Information Request Response

To	The BUSY School C/- Bespoke P&D	Date	16 June 2025
Prepared by	Casey Schackow, Velocity, Director	Approved by	Harj Singh, Traffic Engineering Advisor (RPEQ 22364)
Location	153 Dalrymple Road, Garbutt		
Status	Final	Attachments	Appendix A: Information Request Plans Appendix B: Development Plans Appendix C: Swept Path Assessment Appendix D: SIDRA Assessment

Velocity has been commissioned by The BUSY School C/- Bespoke P&D to provide traffic and transport advice in response to the items within the Information Request (IR) #MCU25/0013, for the proposed development located at 153 Dalrymple Road, Garbutt.

Information Request

Figure 1 Indicative Bus Set Down Area

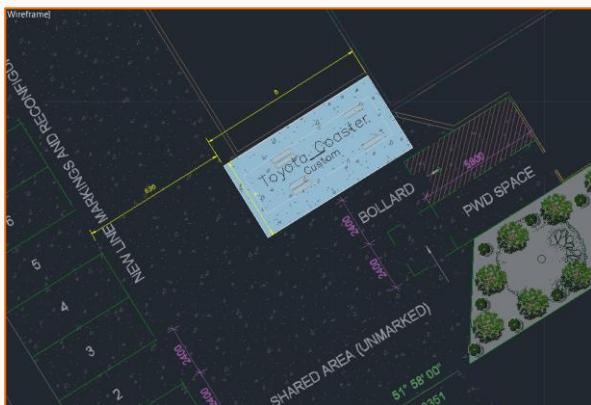
- a) Confirmation of the age of students attending the proposed educational establishment
- b) The number of students able to be collected via shuttle bus;
- c) Details of bus pick-up and set-down for the shuttle bus.

- confirmation of the age of students attending the proposed educational establishment;
- the number of students able to be collected via shuttle bus; and
- details of bus pick-up and set-down for the shuttle bus.

The Toyota Coaster is proposed to set-down within the site, in the available space adjacent the PWD parking space. This area has sufficient room to cater for the 7m long x 2.1m wide bus with adequate room for alighting. Specifically, the available area for the bus set down is proposed to measure 8m x 4m as shown indicatively in Figure 1.

Figure 5 Dalrymple Road / Bayswater Road intersection - SIDRA Layout

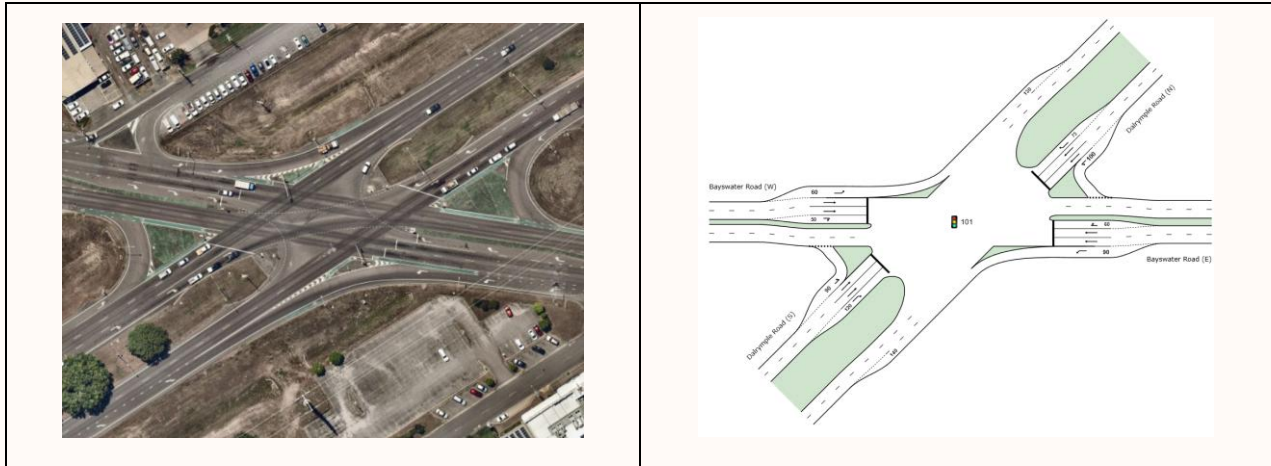
- a) The applicant is requested to provide an amended Traffic Impact Assessment (TIA) report certified by an RPEQ and which meets the requirements of a Moderate TIA in accordance with SC6.4 Development manual planning scheme policy of the Townsville City Plan. Per SC6.4.5.2(2)(c), “a moderate level TIA Report will be performed using traffic forecasting processes or computerised methods (e.g., Sidra) to estimate and analyse traffic flows on the surrounding road network at predefined time horizons.”
- b) The amended TIA is also requested to include swept path analysis diagrams for the shuttle bus manoeuvres demonstrating that the shuttle bus can safely manoeuvre on the site and enter and exit in a forward gear

Scenario	DOS	Critical Delay	95th %ile Queue	Critical Movement
2025 BG	0.879	101.1 sec	288.3m	Western Right
2025 BG + DEV	0.892	104.3 sec	292.1m	Western Right

Scenario	DOS	Critical Delay	95th %ile Queue	Critical Movement
2025 BG	0.880	63.4 sec	202.4m	Southern Right
2025 BG + DEV	0.888	63.9 sec	210.2m	Southern Right

The results presented in Table 8 and Table 9 above suggest that the intersection is within acceptable performance thresholds for a signalised intersection (i.e. DOS less than 0.9) in all scenarios.

SITE PLAN

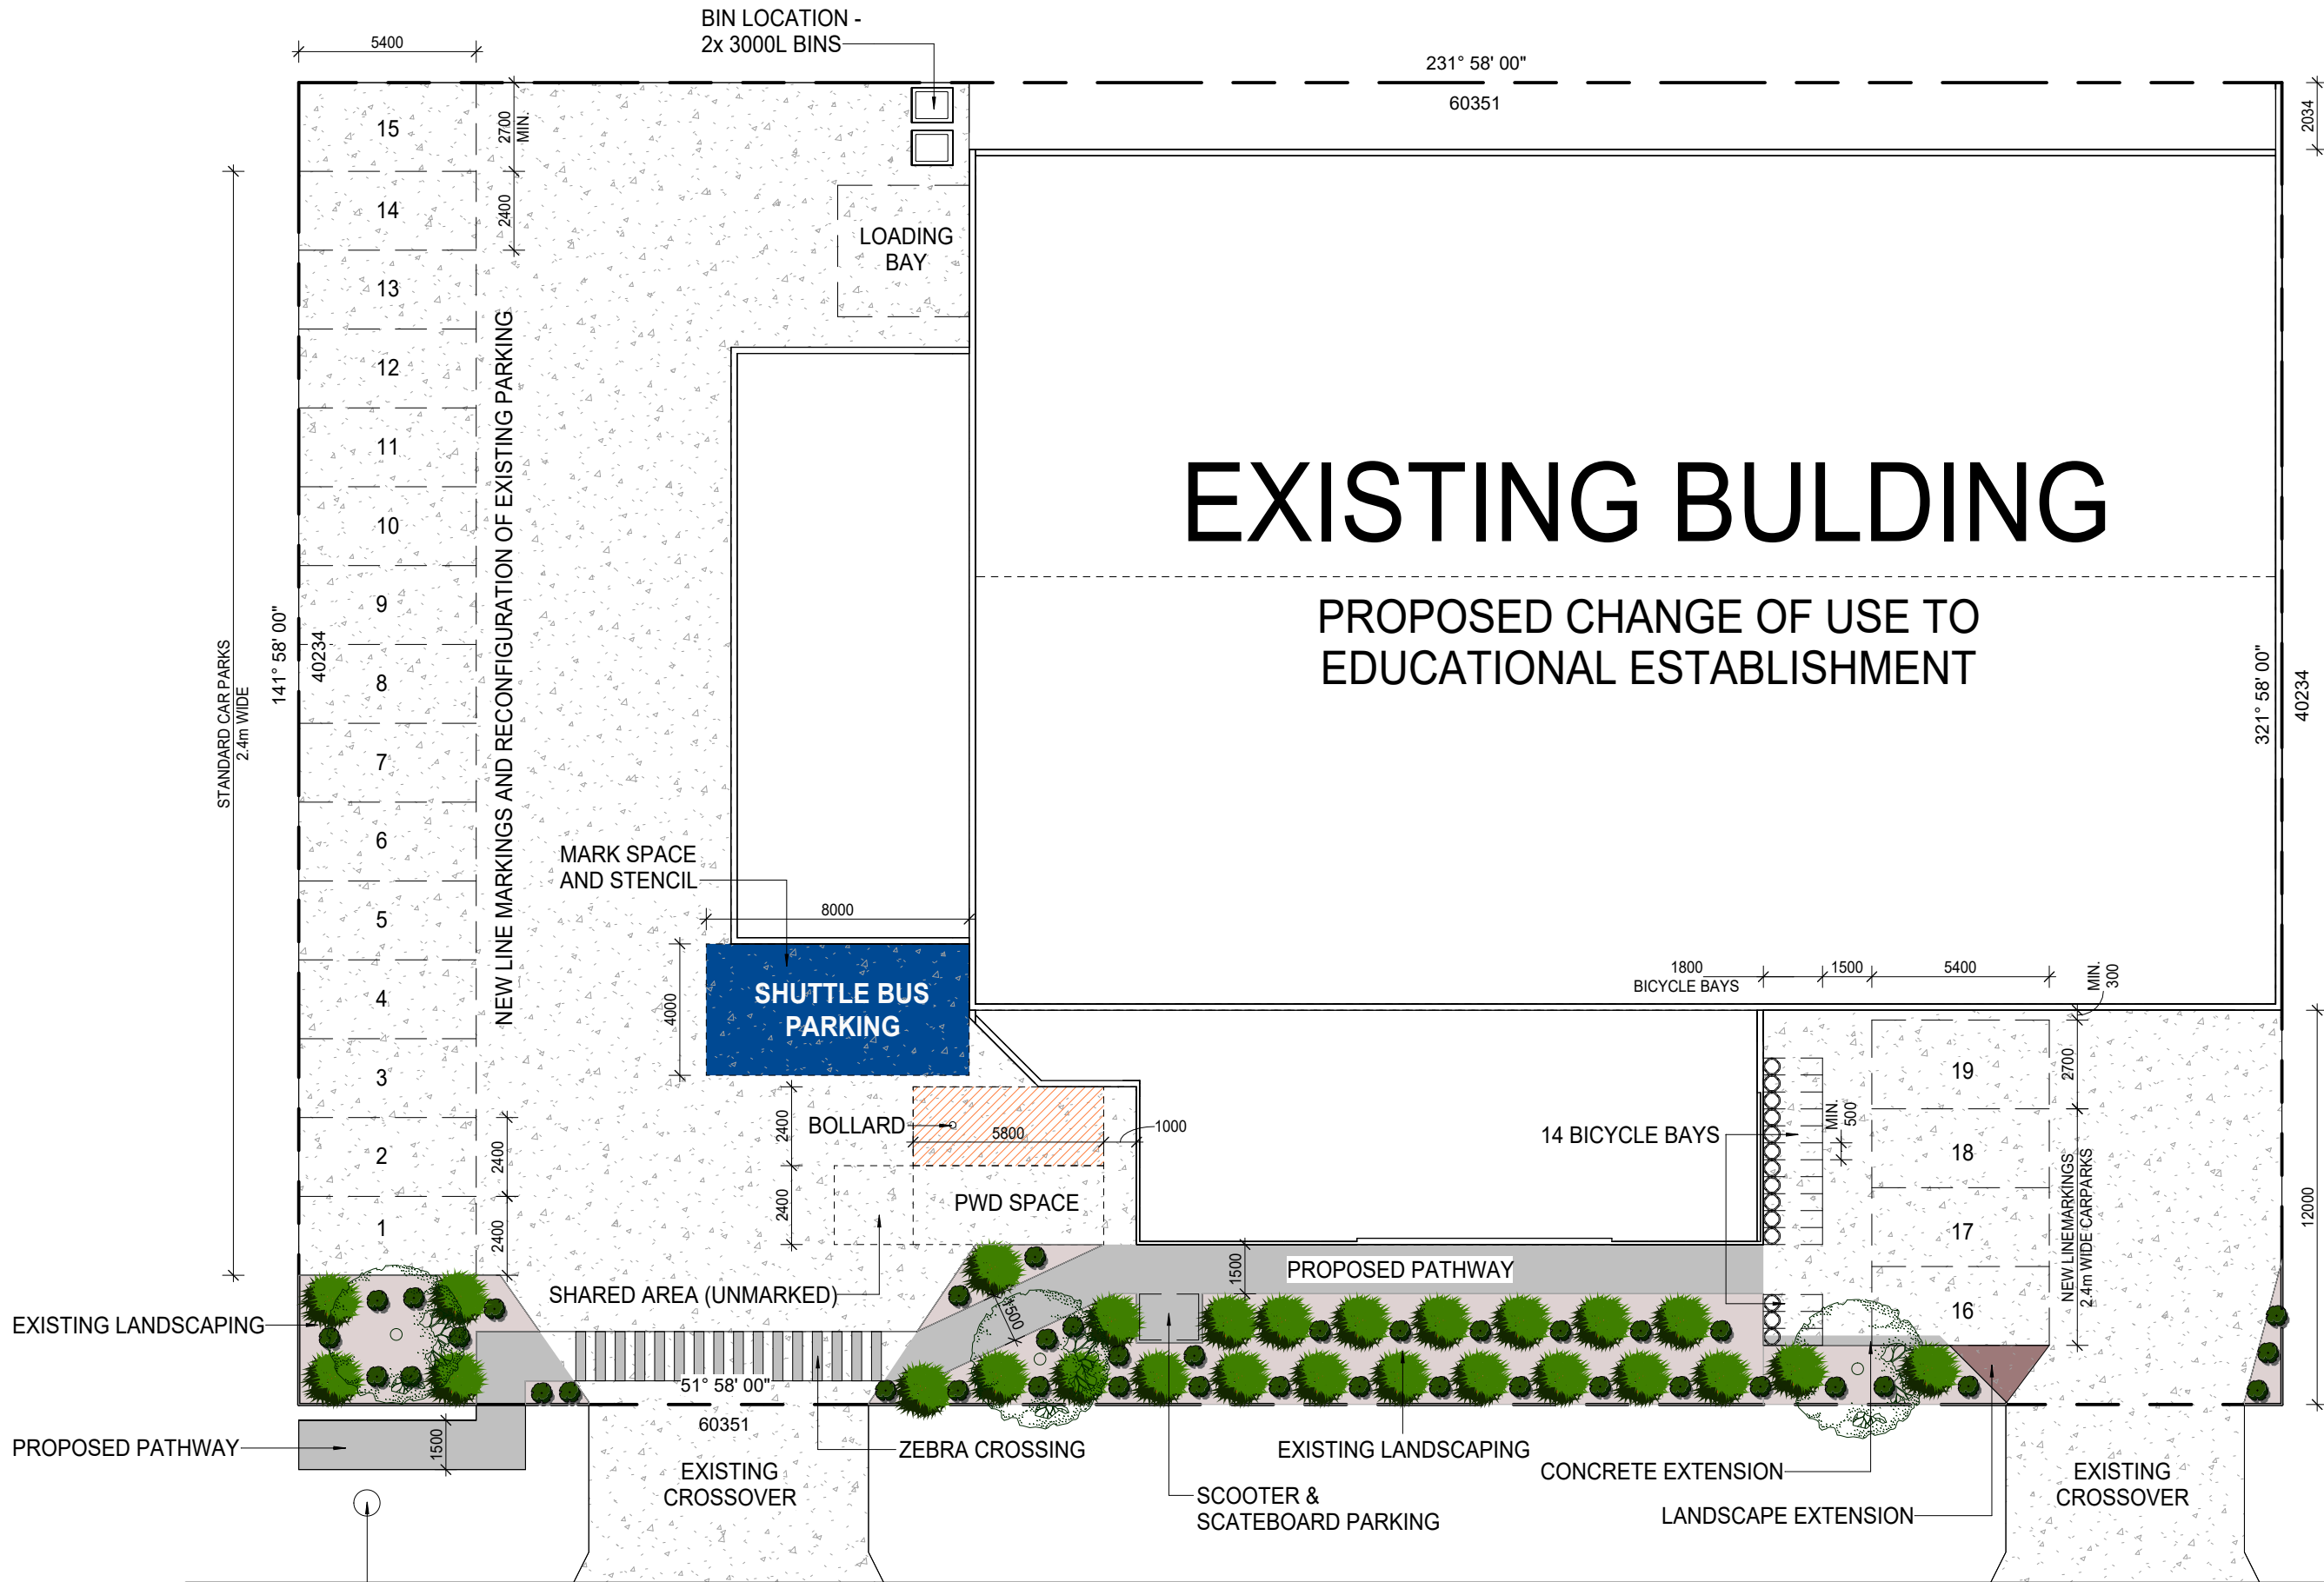
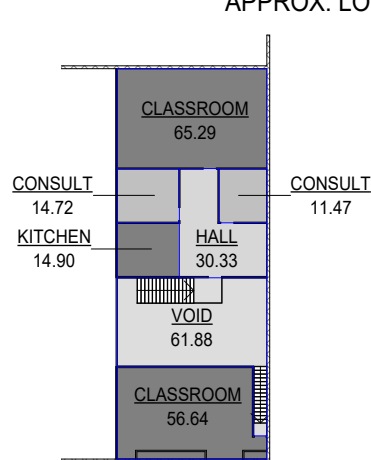
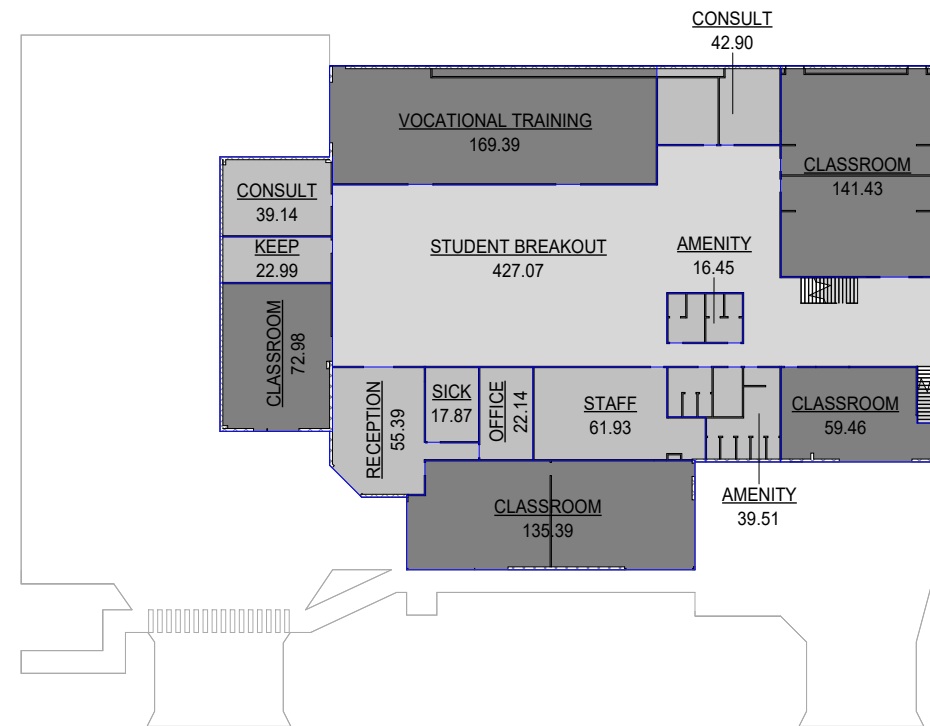
As noted in the planning report, the provision of shuttle bus may alleviate this shortfall somewhat, but in order to do so, it must be able to safely enter and exit the site as there are no drop-off facilities explicitly denoted on the plans and Council requires an understanding of how many students will be able to use this service.

The development plans have been updated to improve the safety and overall amenity for the future students at the site. The changes are focused on improving connectivity and capacity of active transport facilities to increase uptake.:

- ▶ The bicycle parking spaces have been relocated in front of the car parking bays with adequate space left for the bicycles to be parked in accordance with AS2890.3. Additional bicycle spaces have been provided, the new total is 16 spaces

- ▶ A scooter/skateboard parking area has been provided adjacent the main building entrance
- ▶ A footpath has been provided to link the bicycle parking and aforementioned scooter/skateboard parking to the front entrance, separated from all vehicle manoeuvres.

- ▶ The PWD space and shared space has been shifted back 1m to allow direct access from the new footpath
- ▶ A zebra crossing (pedestrian priority) has been provided across the main entrance crossover to ensure safety of pedestrians crossing into the site from Dalrymple Service Road.

- A section of path has been added opposite the new zebra crossing as a landing for pedestrians which is then funnelled through a new footpath along the frontage to the west, where majority of active and public transport users will travel from.
